<b>Wulfsberg Electronics</b> <i>A Chelton Group Company</i>			
<b>APPROVALS</b>	<b>DATE</b>			<b>TITLE:</b>	
DRAWN Leslie Evans	2/22/05	<b>SERVICE INSTRUCTION WSI IDU-III-2  (ENCODER KNOB REPLACEMENT)</b>			
CHECKED C. Baker	2/22/05				
PRODUCT MANAGER R. Durall	2/22/05				
ENGINEER C. Baker	2/22/05	SIZE A	CAGE CODE <b>1B7G3</b>	DWG NO. <b>150-045285</b>	REV <b>A</b>
ISSUED R. Talken	3-3-05	SCALE: NONE		DO NOT SCALE DRAWING	
<b>Typed signatures indicate approval. Handwritten signature approval of this document is on file at Wulfsberg Electronics, Prescott, Arizona.</b>

## **SERVICE INSTRUCTION**

**EQUIPMENT:** IDU-III

**INSTRUCTION NUMBER:** WSI IDU-III-2 Revision A

**Figure 1 Old style knobs**

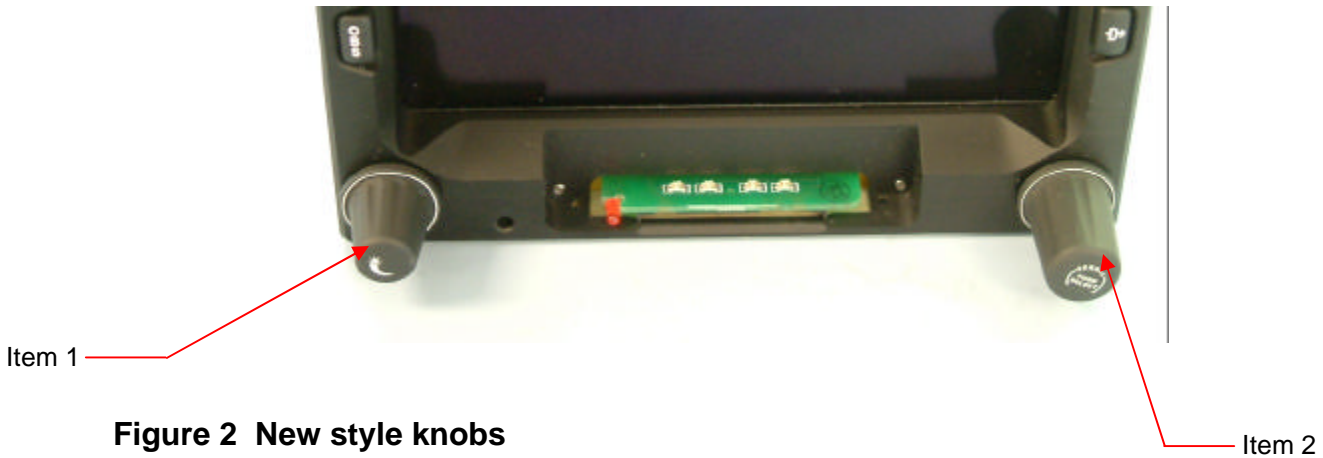
This modification replaces the original encoder knobs with new knobs. The original knobs have a tendency to slide on the encoder shaft when pressing on the knob, causing the "Enter" function or the button dimming function not to work after time.

Remove old knobs (Rev A) and install new knobs (Rev B or higher).

1. Remove original right-hand knob (P/N 180-045102-01) by grasping the knob with fingers and pulling straight out from IDU. This knob has a smooth, plastic finish (see Figure 1).

3. Install new right-hand knob (Item 2) (P/N 180-045102-01 Rev B or later) by lining encoder key slot with knob and pushing knob until fully seated. This knob has a rubberized finish (see Figure 2).
4. Remove original left-hand knob (P/N 180-045101-01) by grasping the knob with fingers and pulling straight out from the IDU. This knob has a smooth, plastic finish (see Figure 1).

6. Install new left-hand knob (Item 1) (P/N 180-045101-01 Rev B or later) by lining encoder key slot with knob and pushing knob until fully seated. This knob has a rubberized finish (see Figure 2).
